Plexus Adequacy Review

February 12, 1993

SUBJECT: Waste Rock Monitoring for ARD at the
Bornite Mine (24-0076)

fig 2

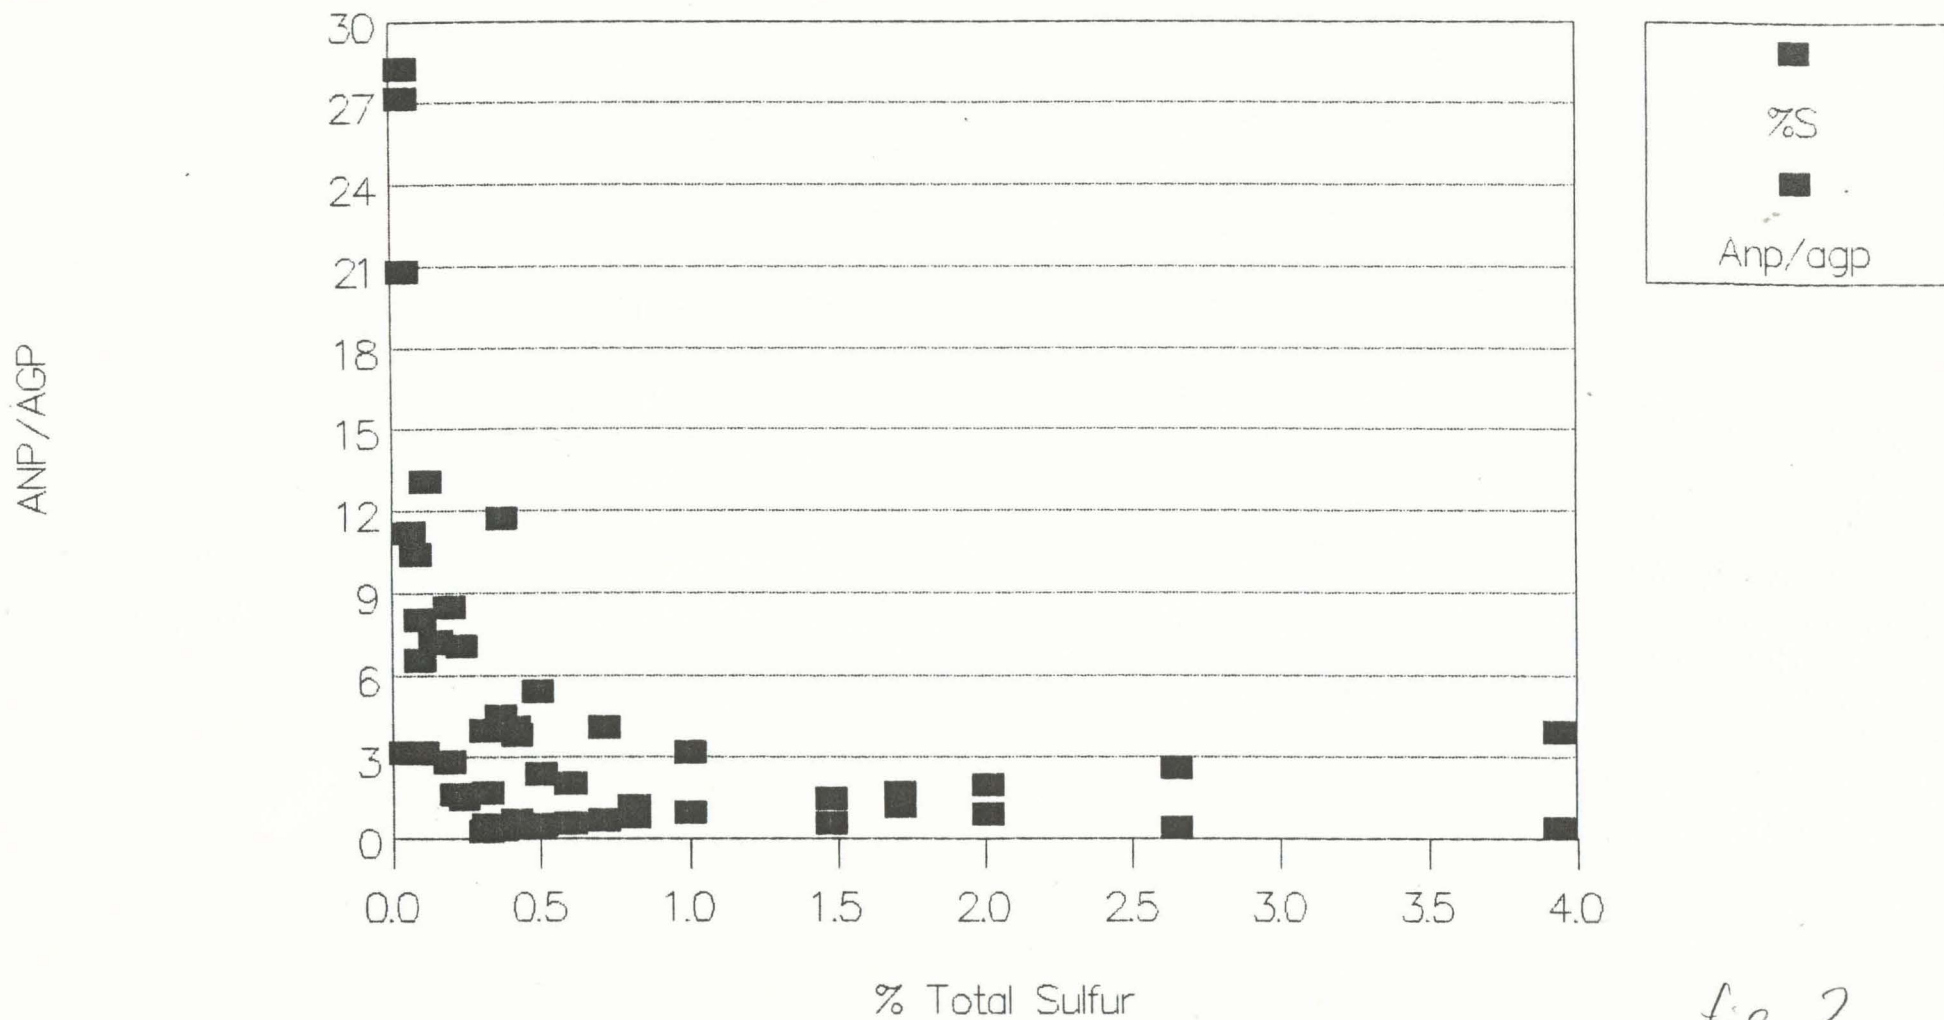
The attached Figure 1 shows a plot of the waste rock data submitted by Plexus (from DOGAMI Application, Table 6, samples with anp/agn > 30 omitted). There are two samples with greater than 0.6% pyrite and an anp/agn < 3. These rock would need to be segregated and eventually used as backfill.
